то: Mercedes-Benz Dealer Principals, General	FROM: Thomas Brunner, Department Manager,	
Managers, Sales Managers, Service Managers,	Vehicle Compliance and Analysis, Engineering	
Parts Managers	Services	
RE: Recall Campaign 2016040005 - Model 172		
(SLK-Class), Model Year 2016		
Correct Pin Assignment at Driver-side SAM	DATE: May 2, 2016	
Control Module and SCN Code Rear SAM		
Control Module

Recall Campaign Bulletin

Campaign No. 2016040005, April 2016

Correct Pin Assignment at Driver-side SAM Control Module and SCN Code Rear

Figure 1

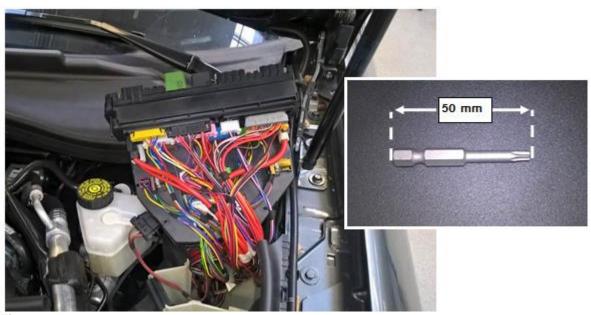
- 1. Remove Driver-side SAM control module with left front fuse and relay box from fuse box with harness connectors connected, refer to WIS: AR54.21-P-1260CW.
  - i Note:
  - Disconnect negative battery cable refer to WIS: AR54.10-P-0003W.
  - Do not disconnect electrical harness connectors.
  - Use a 50 mm long Torx-bit T20 (locally sourced) to unbolt driver-side SAM control module from fuse box.

Figure 3

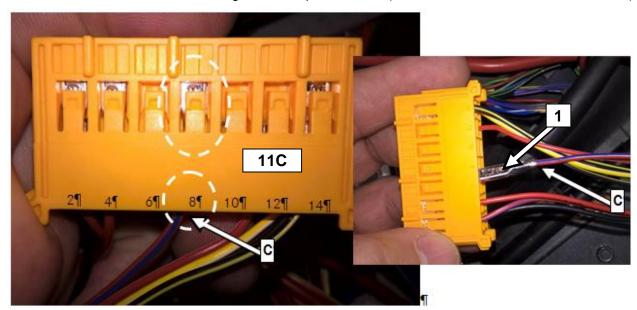
- 3. Unpin **red-blue** wire (pin 8 at orange connector [11C], Figure 3) using pin removal tool \* then cut off female wire connector (1).
  - \* 220 589 01 99 63 found in wiring harness repair kit, basic (000 589 13 99 00 and 220 589 04 99 00).

- 4. Re-connect orange connector 11C (Figure 3) to driver SAM.
- 5. Crimp **new** female wire connector (with 0.75 mm²) to **blue-red** wire (C, Figure 3).

Figure 4

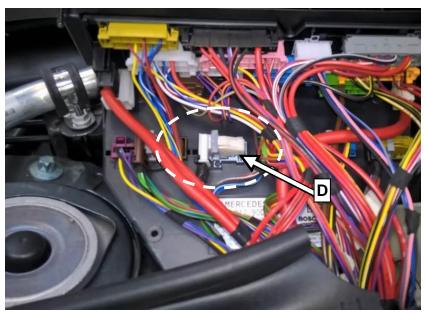
6. Disconnect white harness connector (D, [19I] Figure 4) from driver SAM and cut-off cable tie.

Figure 5

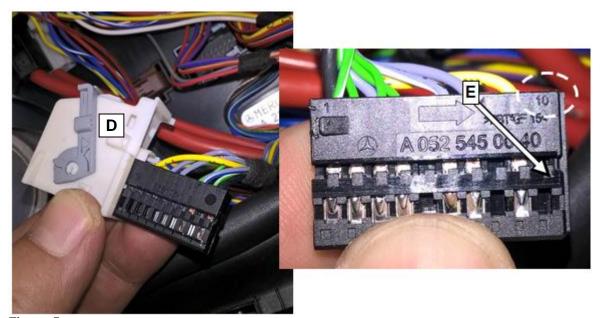
7. Open/unlock connector (D, [19I] Figures 4, 5) and insert **red-blue** wire (C, Figure 3) into position 10 (E, Figure 5).

- 8. Close/lock white connector (D, [19I] Figure 5) and re-connect to driver SAM.
  - Note: Install new cable tie on connecter (D) wiring harness.
- 9. Re-install Driver-side SAM control module into left front fuse and relay box.
- 10. Reconnect battery.
